**COMMISSION REGULATION (EU) 2017/1154****of 7 June 2017**

**amending Regulation (EU) 2017/1151 supplementing Regulation (EC) No 715/2007 of the European Parliament and of the Council on type-approval of motor vehicles with respect to emissions from light passenger and commercial vehicles (Euro 5 and Euro 6) and on access to vehicle repair and maintenance information, amending Directive 2007/46/EC of the European Parliament and of the Council, Commission Regulation (EC) No 692/2008 and Commission Regulation (EU) No 1230/2012 and repealing Regulation (EC) No 692/2008 and Directive 2007/46/EC of the European Parliament and of the Council as regards real-driving emissions from light passenger and commercial vehicles (Euro 6)**

Figure 1

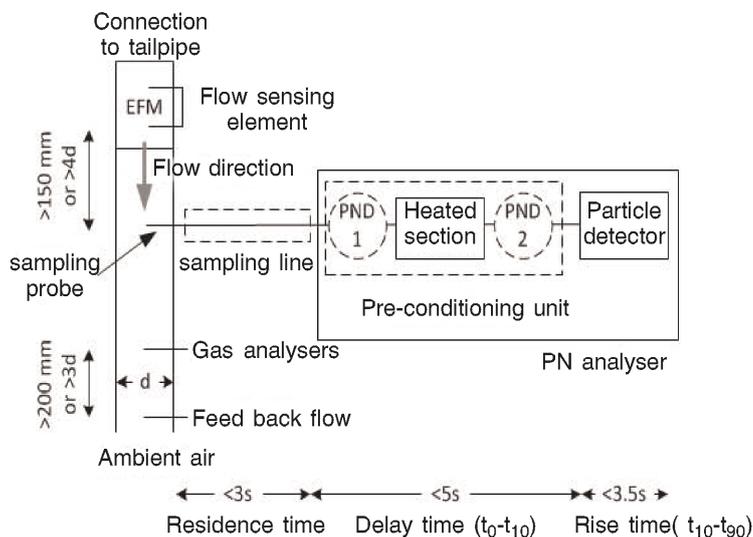
The PN analyser shall consist of a pre-conditioning unit and a particle detector that counts with 50 % efficiency from approximately 23 nm. It is permissible that the particle detector also pre-conditions the aerosol. The sensitivity of the analysers to shocks, vibration, aging, variability in temperature and air pressure as well as electromagnetic interferences and other impacts related to vehicle and analyser operation shall be limited as far as possible and shall be clearly stated by the equipment manufacturer in its support material. The PN analyser shall only be used within its manufacturer’s declared parameters of operation.

The PN analyser shall be connected to the sampling point via a sampling probe which extracts a sample from the centreline of the tailpipe tube. As specified in point 3.5 of Appendix 1, if particles are not diluted at the tailpipe, the sampling line shall be heated to a minimum temperature of 373 K (100 °C) until the point of first dilution of the PN analyser or the particle detector of the analyser. The residence time in the sampling line shall be less than 3 s.

The PN analyser shall include a heated section at wall temperature  $\geq 573$  K. The unit shall control the heated stages to constant nominal operating temperatures, within a tolerance of  $\pm 10$  K and provide an indication of whether or not heated stages are at their correct operating temperatures. Lower temperatures are acceptable as long as the volatile particle removal efficiency fulfils the specifications of 6.4.
